1 GREENLINE REVISION 8/18/10

REVISION "C"

U.S 13 (BUS.) (FRUITLAND BLVD) AND EAST MAIN STREET.

GENERAL INFORMATION SHEET

WIRING DIAGRAM

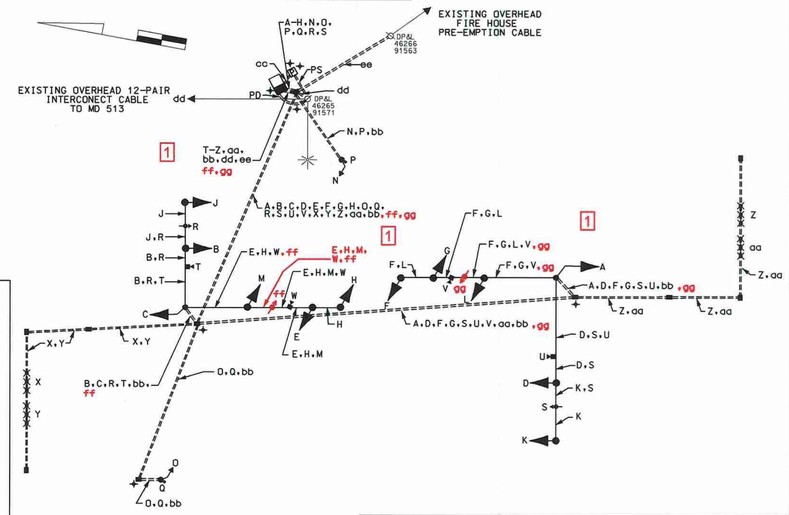
1 **A new pre emption phase for the eastbound approach of Main Street shall now operate when activated via opticom detection.**

8025	Video detection camera & cable up to 500'	4 EA
8030	Disconnect, pull back and reroute cable.	235 L.F.
1 8032	Schedule 80 rigid PVC conduit up to 4" - bored.	810 ~~750~~ L.F.
8034	Schedule 80 rigid PVC conduit up to 4" - trenched.	1200 L.F.
8035	Wood sign supports up to 4"x6".	225 L.F.
8036	Install overhead or ground mounted sign (including hardware).	179 S.F.
8038	No. 6 AWG stranded bare copper ground wire.	550 L.F.
8041	Metered service pedestal embedded.	1 EA
8043	Electrical cable 1-conductor No. 4 AWG THHN/THWN.	60 L.F.
1 8045	Furnish and install electrical handhole.	13 ~~11~~ EA
8046	Discriminator module, 4 channel No. 764	1 EA
1 8048	Opticom #721 detector eye.	4 ~~2~~ EA
8049	3 inch diameter PVC conduit schedule 80, riser	200 L.F.
8050	12" LED signal head section.	36 EA
1 8051	Furnish and install 4 conductor opticom cable.	1040 ~~550~~ L.F.
8054	Electrical cable - 2 conductor (No. 14 AWG).	300 L.F.

R S ~~ff~~ ~~gg~~ } 4-CONDUCTOR OPTICOM CABLE
